Project: IEEE P802.15 Working Group for Wireless Personal Area Networks (WPANs)

Submission Title: [Comment resolution on the initial SB comment No.109]
Date Submitted: [20th January, 2011]
Source: [Sang-Kyu Lim, Ill Soon Jang, Dae Ho Kim, You Jin Kim, Kang Tae-Gyu] Company [ETRI]
Address: [138 Gajeongno, Yuseong-Gu, Daejeon, Korea]
Voice:[+82-42-860-1573], FAX: [+82-42-860-5218], E-Mail:[sklim@etri.re.kr]

Comment resolution on the initial SB comment No.109

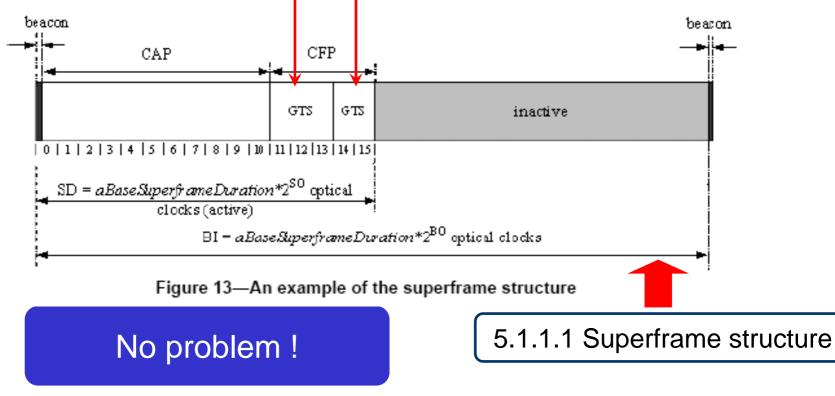
• A VLC enabled dynamic display can be used in the broadcast topology. The VLC broadcast topology in this standard consists of mainly the beacon and the downlink, as shown in Figure 14.

Figure E.5 – VLC broadcast topology construction using the dynamic display

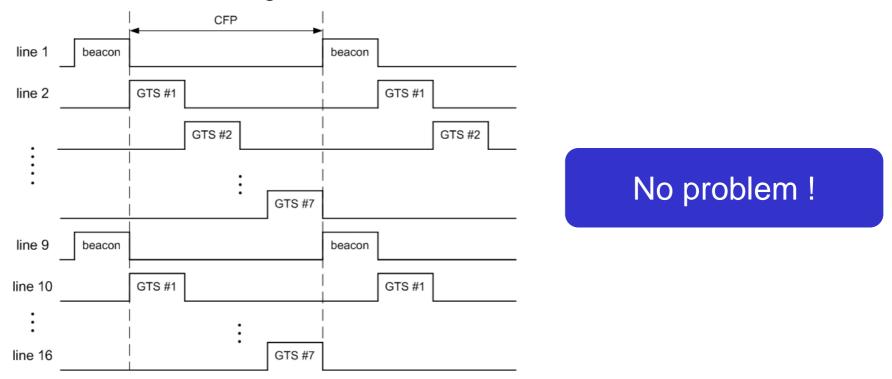
• Figure E.5 shows the VLC broadcast topology construction using the dynamic display. The active time slot #1 is assigned to the beacon and the active time slots from #2 to #8 are assigned to the downlink in Figure E.5.

6th sentence in E.2.3

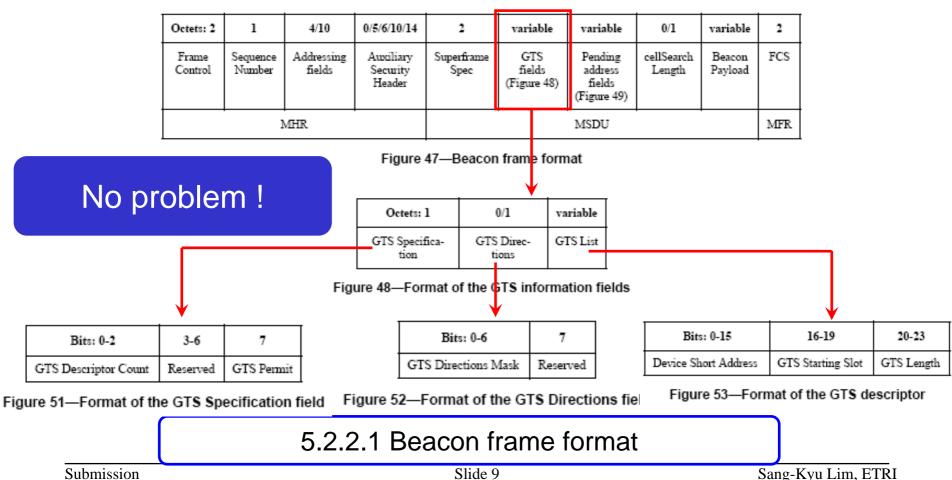
• The GTS fields of the beacon frame can be used to indicate the GTS number, GTS length, and GTS direction for the broadcast topology.

Summary

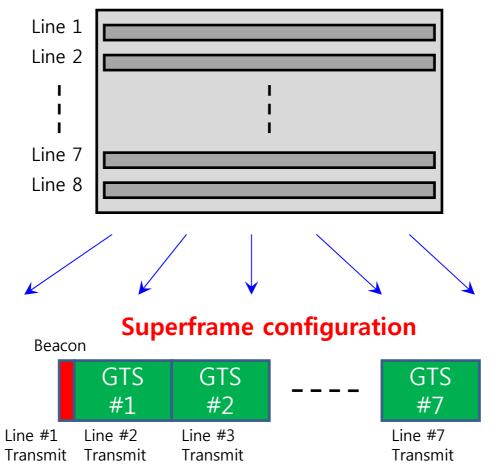
Does a LED display need the individual MAC sub-layers corresponding to each line when a dynamic LED display use GTS mechanism to support the VLC broadcast topology ?

No problem because a dynamic a LED display use only a MAC sub-layer when it use GTS mechanism to support the VLC broadcast topology !
